Ref: 118112_09\240304_Pondicherry_Followup_Review.docx

4 March 2024

**Re: Pondicherry Precinct – Flooding and Water Cycle Management
Review of Flood Assessment**

Figure 1: High velocities modelled within the proposed Pondicherry Lake due to initial water level polygon

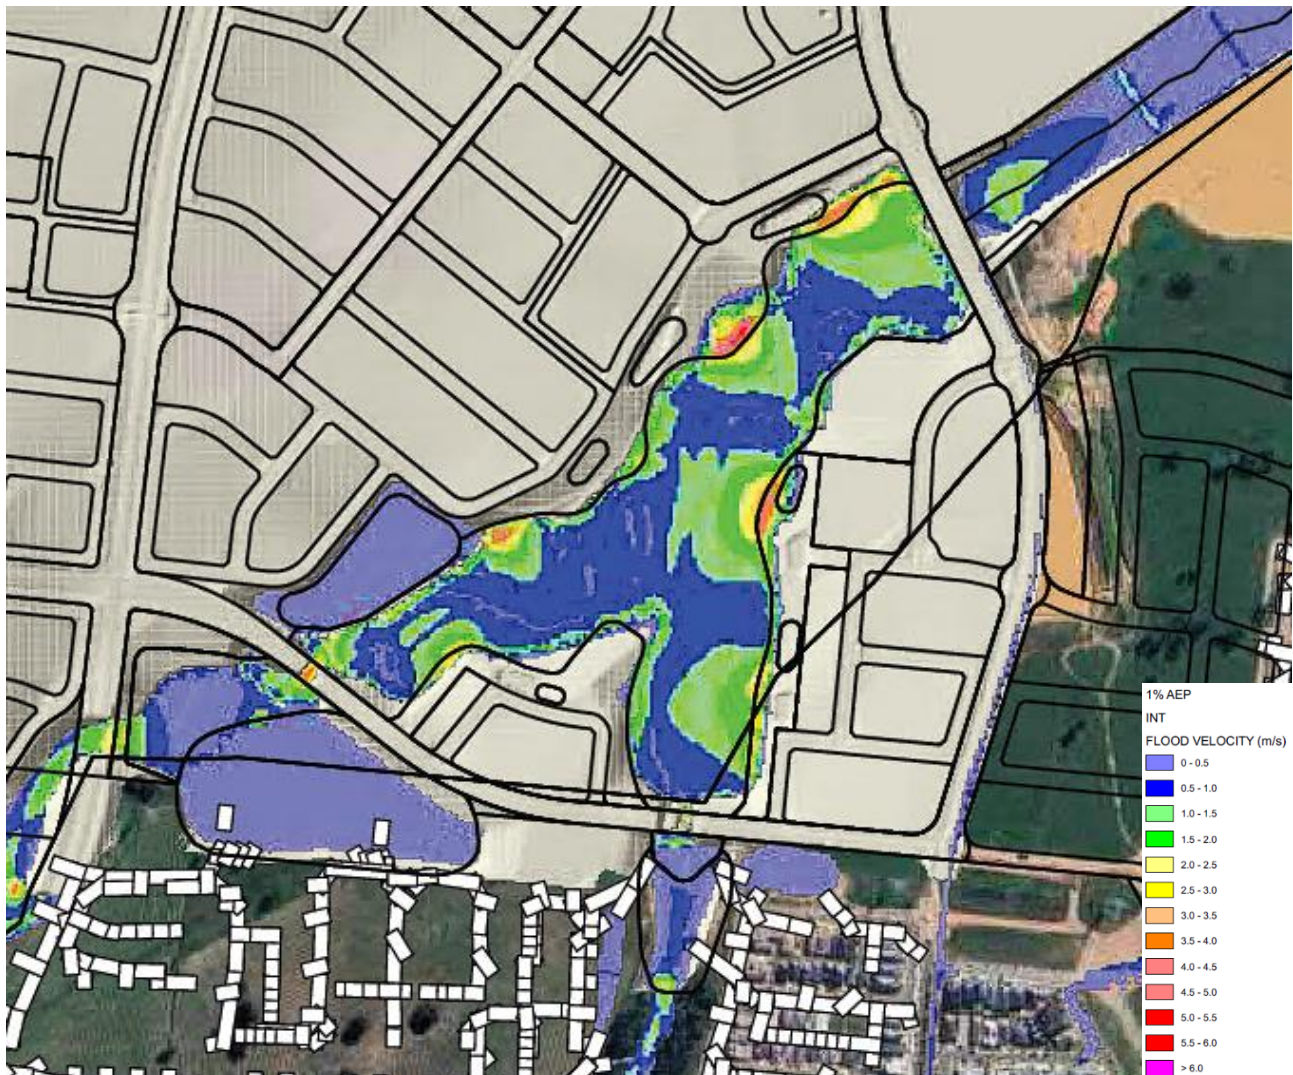
The initial water levels applied are consistent with the updated report and at the levels that represent the lowest outlet level. However, the initial water level polygon for the proposed Pondicherry Lake does not cover the entire lake area. At the start of the simulation this results in a 3 m ‘wall’ of water suddenly being released into ‘dry’ areas of the lake. This results in high velocities simulated within the lake (see in Calibre’s velocity maps), when in reality velocities within storage areas are typically very low. A screenshot is provided in Figure 1.

This considered to be a minor issue that would not have a significant influence on the outcomes of the flood assessment.

Figure 2: Lowering of water levels in the proposed Pondicherry Lake at the start of the simulation

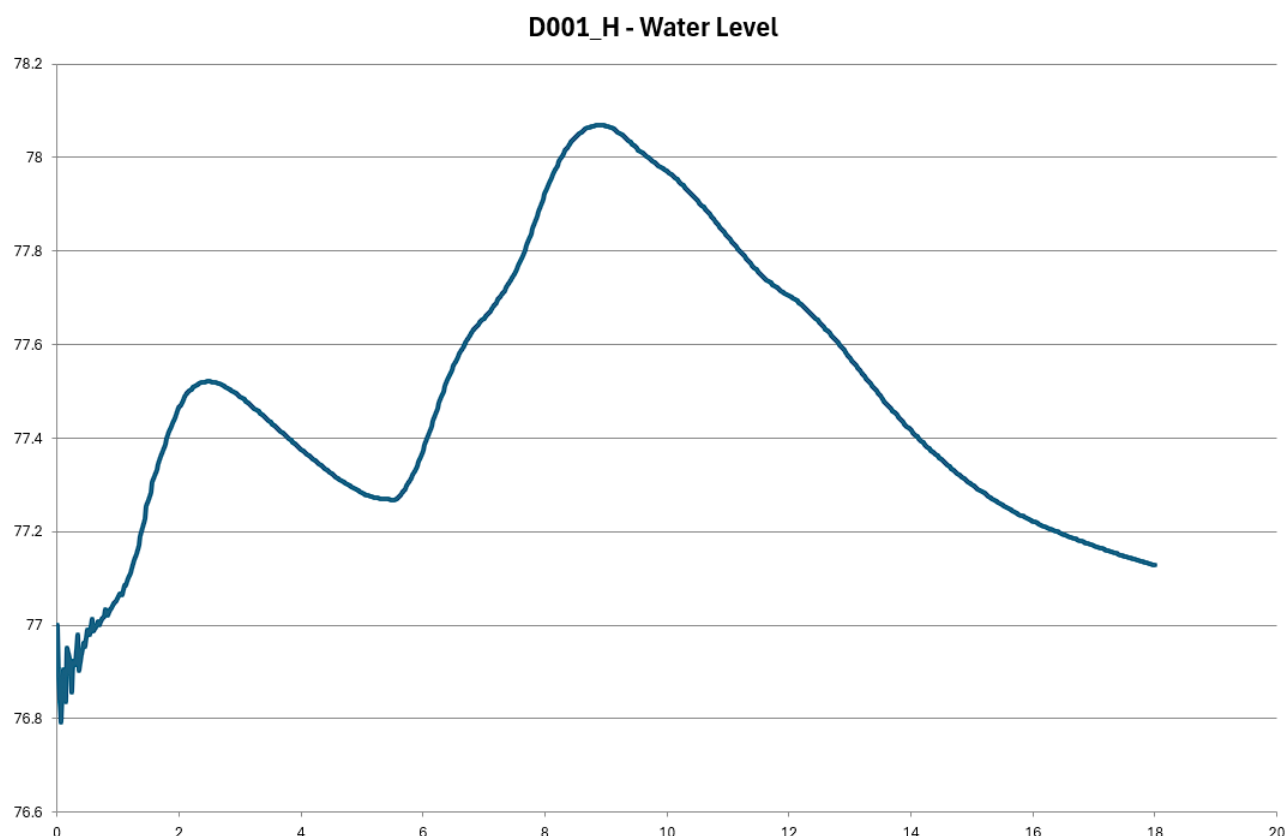
This also results in a lowering of the water level in the entire lake at the start of the simulation, as shown in Figure 2.

Figure 3: Incorrect LFCSH representing a road crossing.

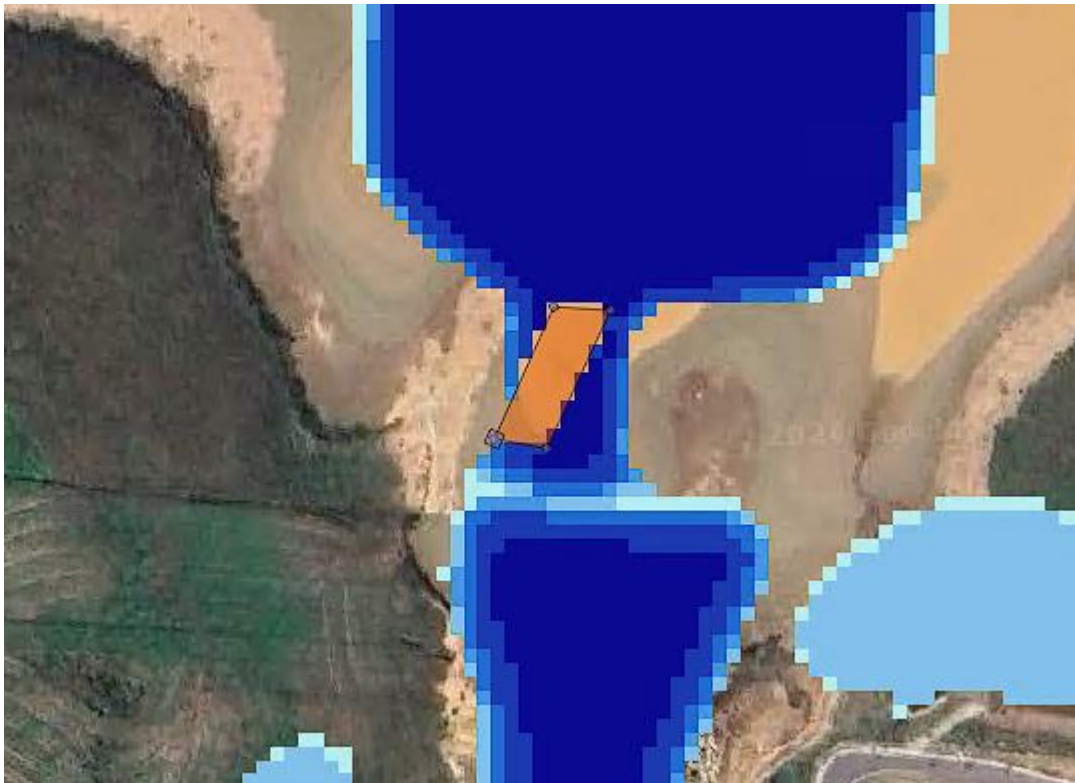
The proposed road crossings have been implemented with 2d_lfcsh polygons. This approach is considered reasonable at this stage of the proposal. However, the eastern road crossing is not implemented correctly and results in a complete blocking of flows., which are diverted around the structure. This is shown in Figure 3. This considered to be a minor issue that would not have a significant influence on the outcomes of the flood assessment.
